SEWAGE DISPOSAL SYSTEM

DEPARTMENT OF HEALTH AND MENTAL HYGIENE

SUBDIVISION Stysley Property LOT 4 ROAD 16429 Old Frederick Road

RE: Well Permit Application
Stysley Property, Lot 4

INDICATE NORTH - NAME ADJOINING ROADWAY AS BASE LINE
 EDWARDS LINE 500 TO OLD PICO RD →

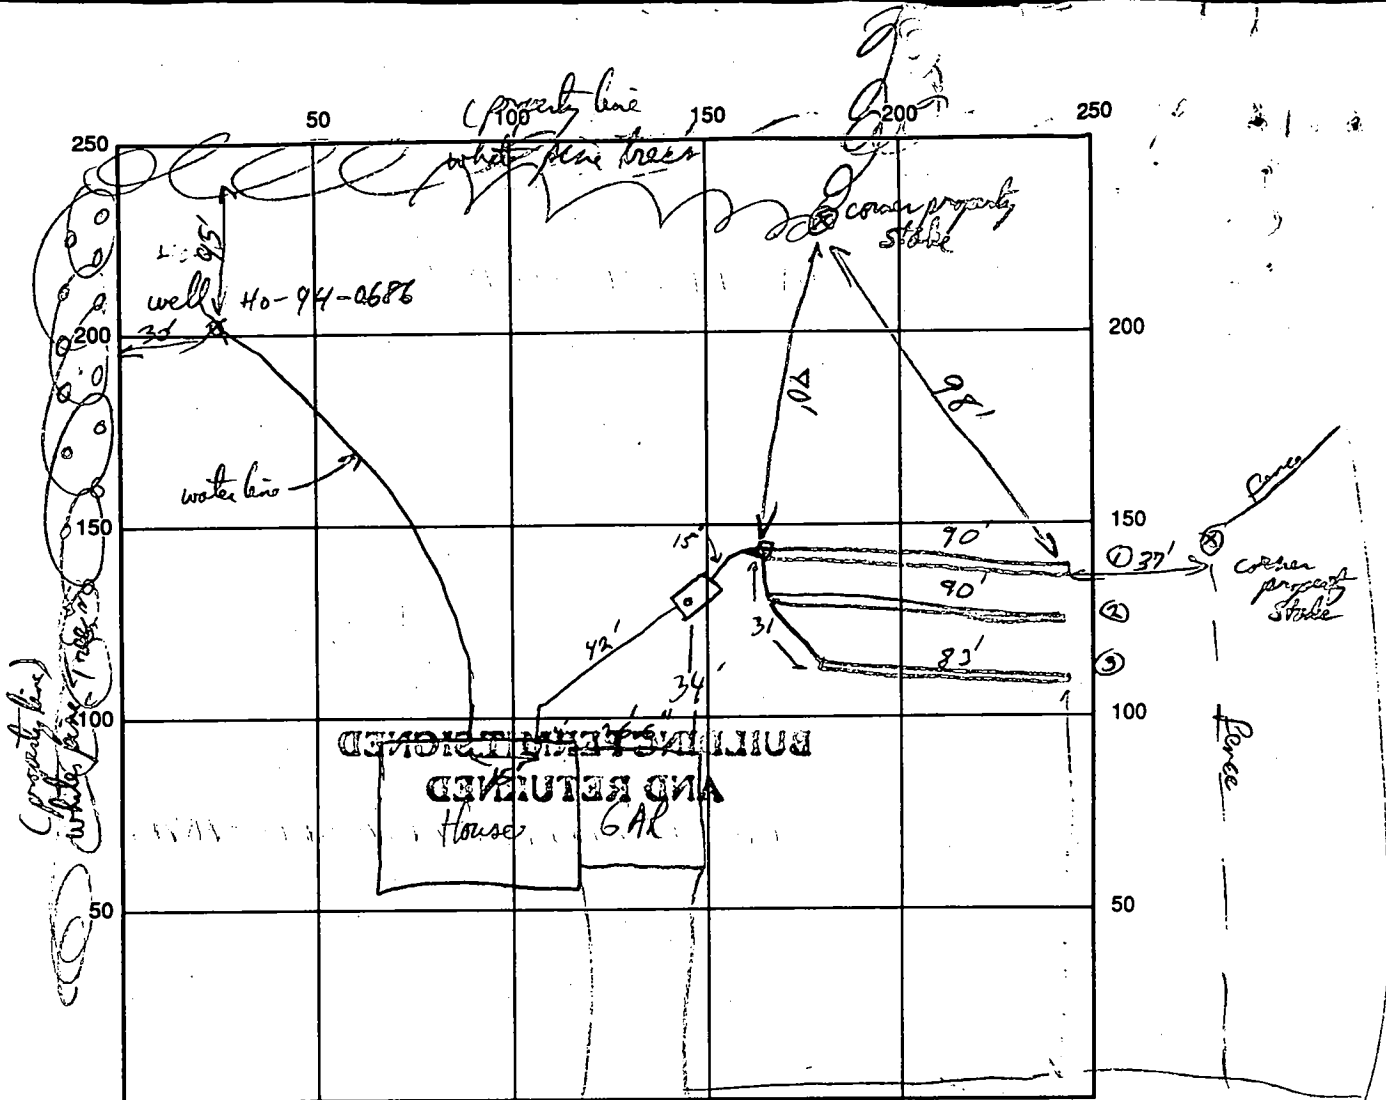
REMARKS: 1-31-96 HOUSE CONNECTION NOT MADE! OK TO COVER

ALL OTHER WORK. OK 2-8-96 HOUSE CONNECTION OK.

MAP OF PROPERTY
HOWARD ASSOCIATES
 SITUATED IN
 4th Election District
 HO. CO. MARYLAND
 SCALE: 1" = 50'
 DRAWN CBM CHECKED _____

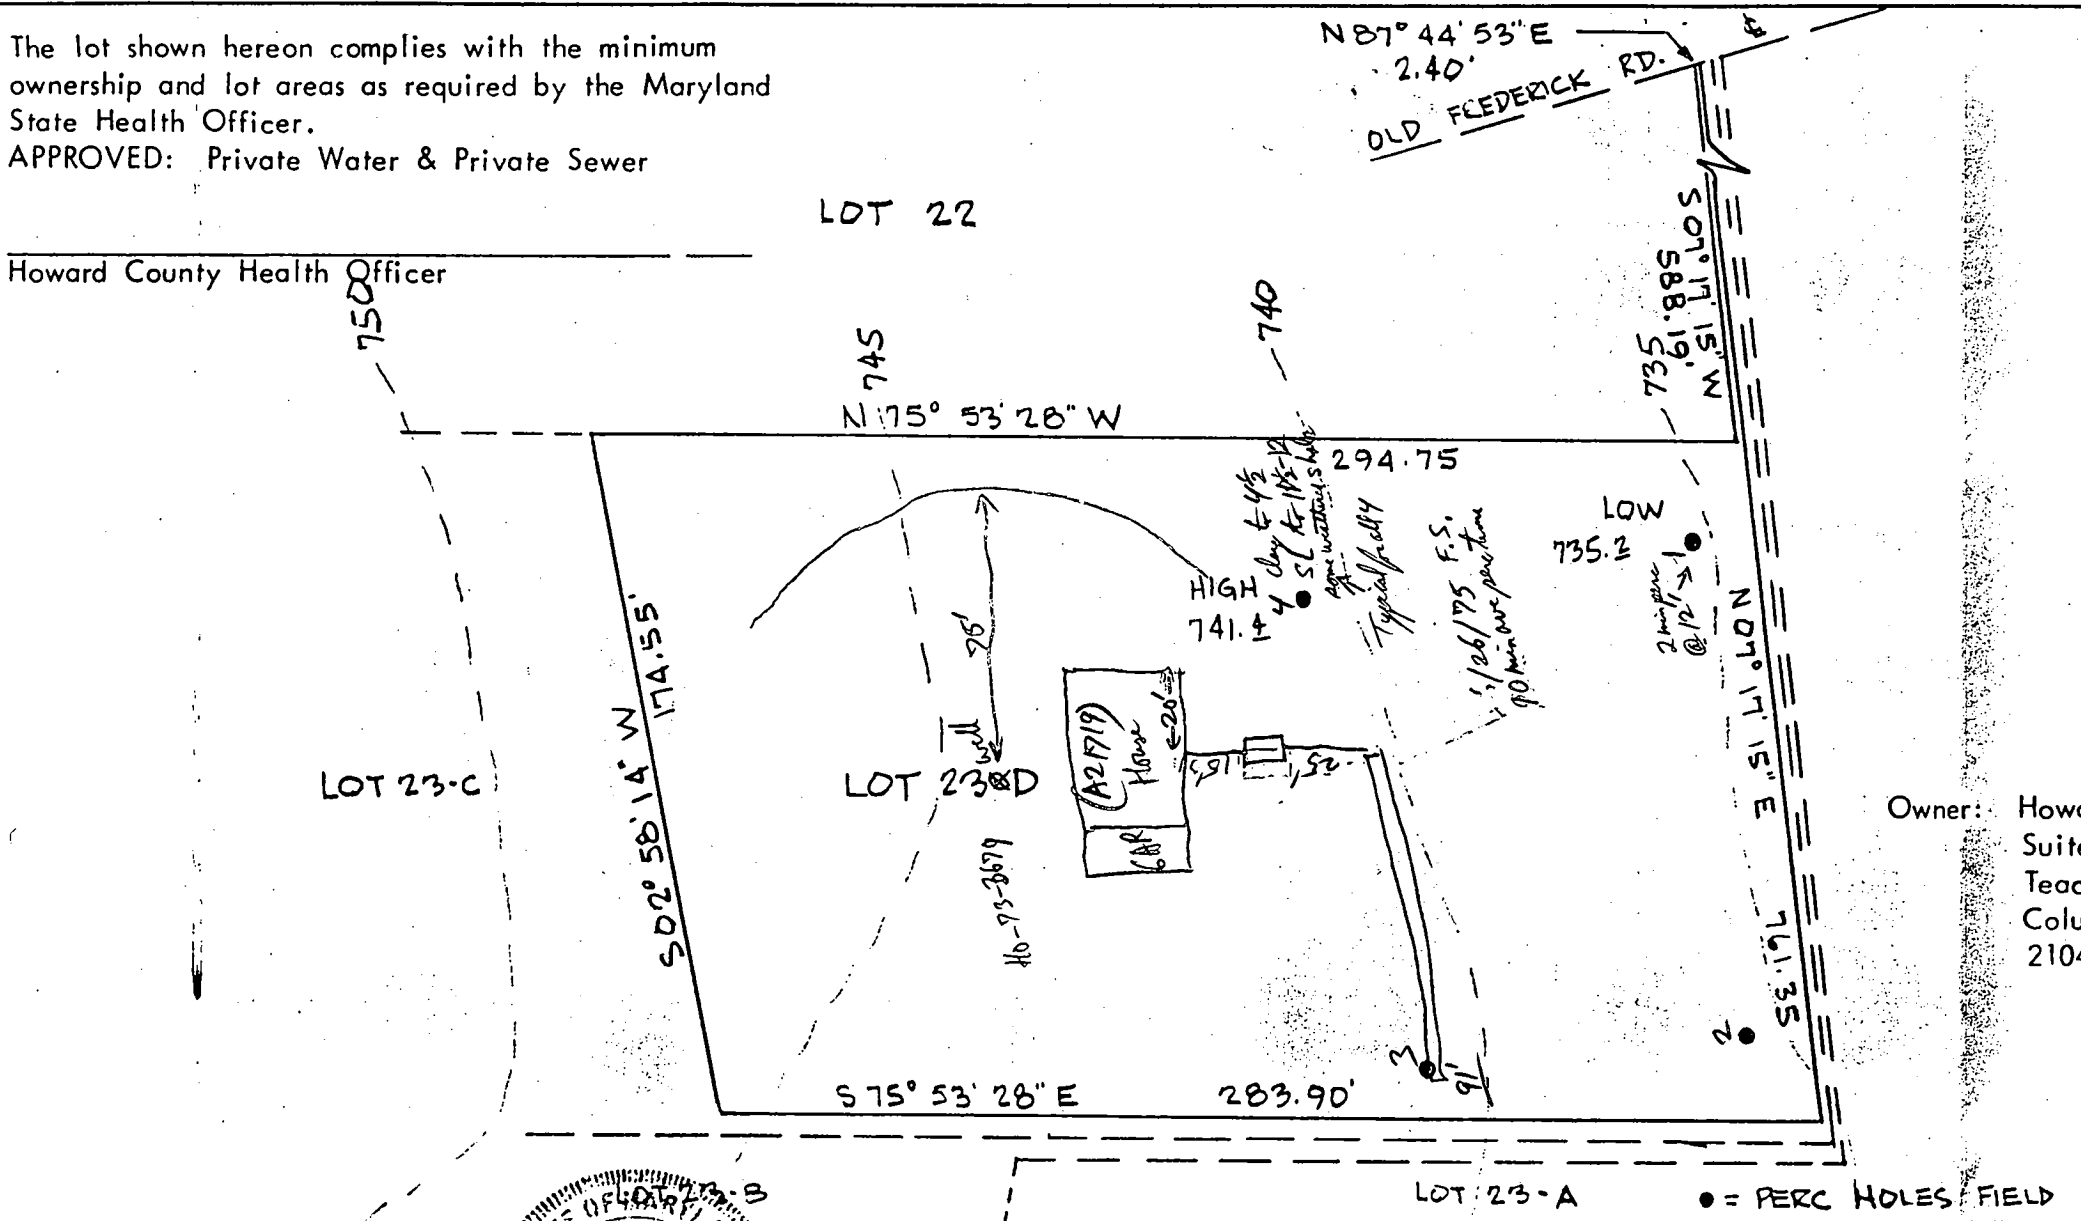
- The approved location was changed to a point that is 100' from the right-rear lot corner and 140' from the closest bend in the right lot line. A copy of the approved location is enclosed.
- An adjustment of the septic area toward the front portion of the property is to be accomplished prior to issuance of the building permit.

BY APPROVAL OF THIS PLAN
THE HEALTH DEPT. ACCEPTS
THE REVISED SEWER
DISPOSAL EASEMENT
AS SHOWN.
